BELL SYSTEM PRACTICES
Teletypewriter and Manual
Telegraph Station and PEX
Installation and Maintenance

ADDENDUM P30.501
Issue A, 3-27-44
Long Lines Department
Dist. Class. 602.02 AC

No. 14 OR No. 15 TELETYPEWRITER

LINE CONNECTIONS

L9.09

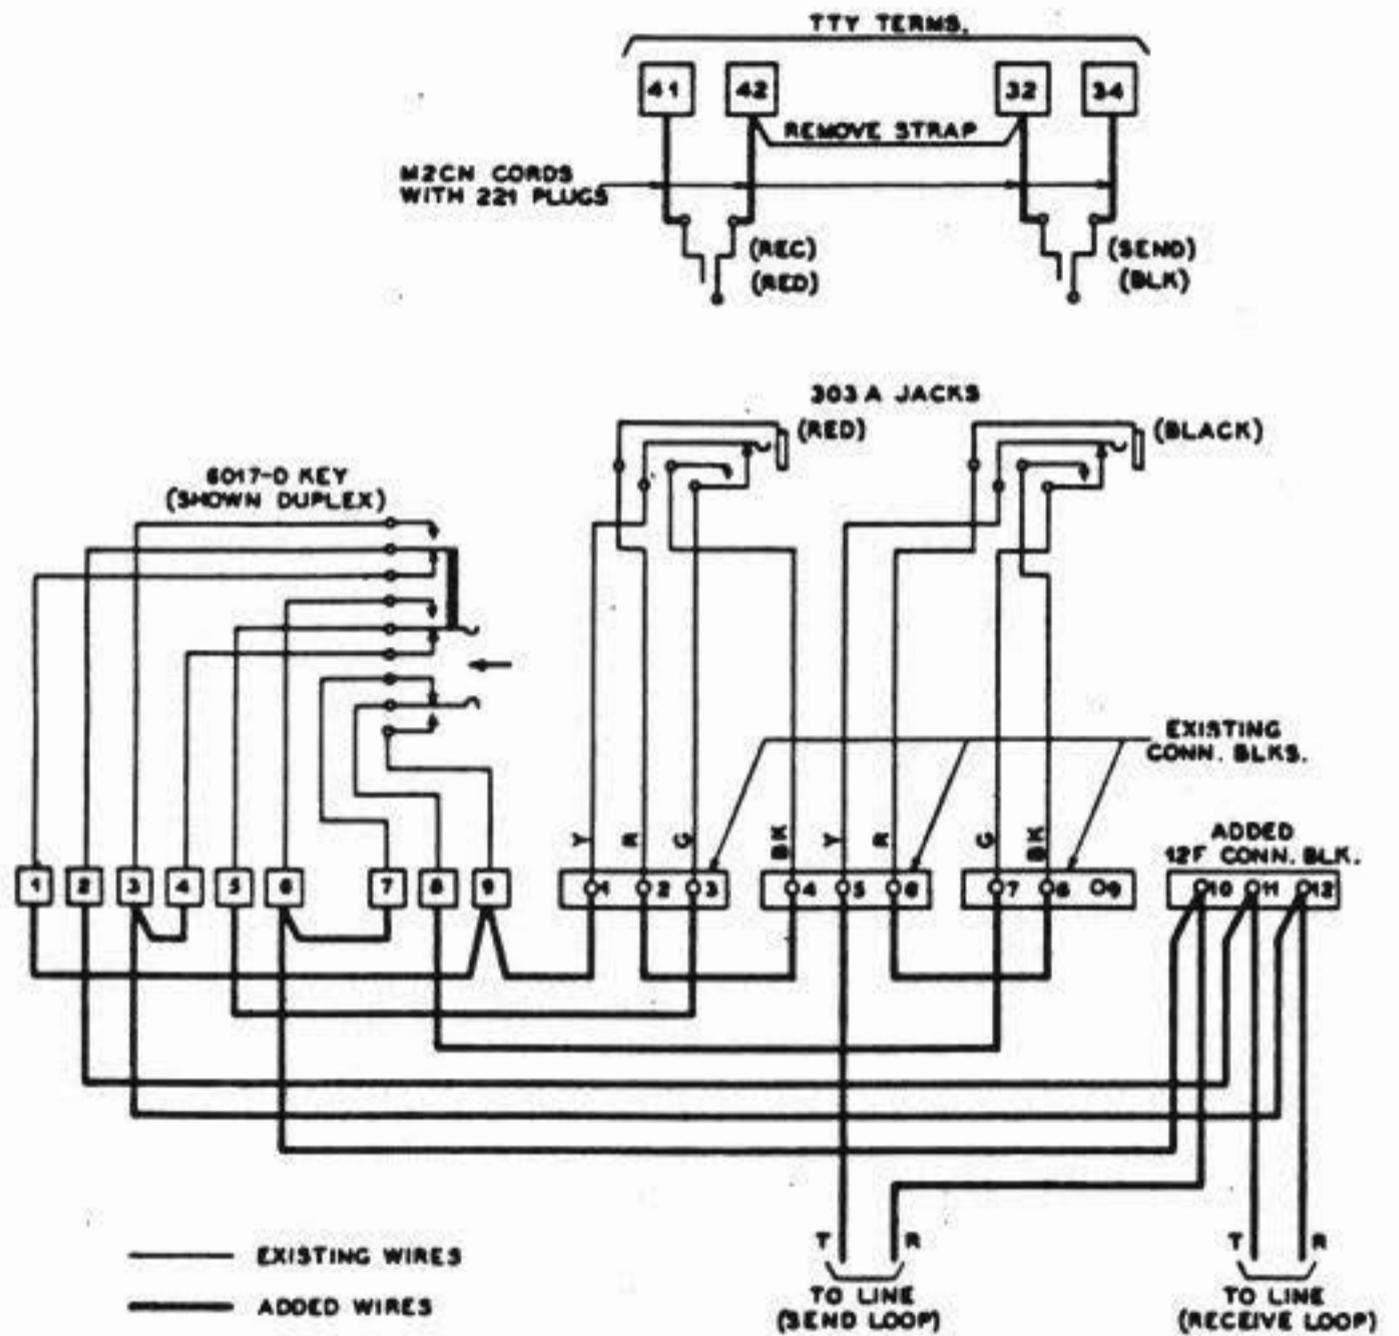
1.01 This addendum is issued to supplement Section P30.501 by adding Plan L9.09 which provides for a key arrangement to obtain single or duplex operation of a 15-type teletypewriter on a 15N table.

1.02 Plan L9.09 is reproduced from Drawing S-9446-143.

NOTE:- ADD P-38857 PLUNGER TO
L-T KEY OF TTY.
